Smiggins Hotel

BCA STATEMENT Access Ramp

REPORT NO: 23007

PREPARED BY: MS | Complete Certification Pty Ltd | BCA Consulting

FIGURE 15(A) RAMP HANDRAILS—EXAMPLES OF HANDRAIL TERMINATIONS

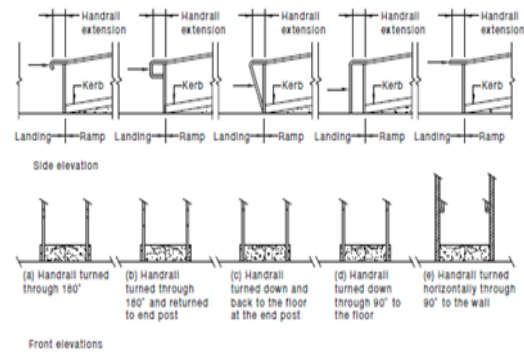
Complies

FIGURE 17 LOCATION OF RAMP TO PREVENT PROTRUSION OF HANDRAILS INTO A TRANSVERSE PATH OF TRAVEL OTHER THAN AT BOUNDARIES

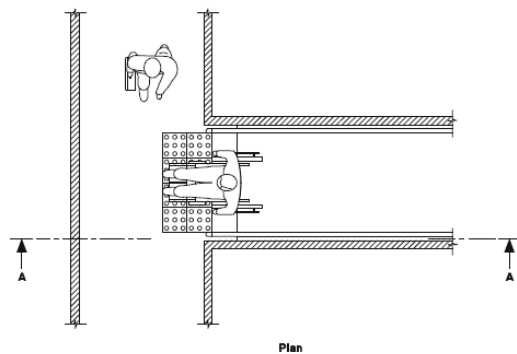
Complies
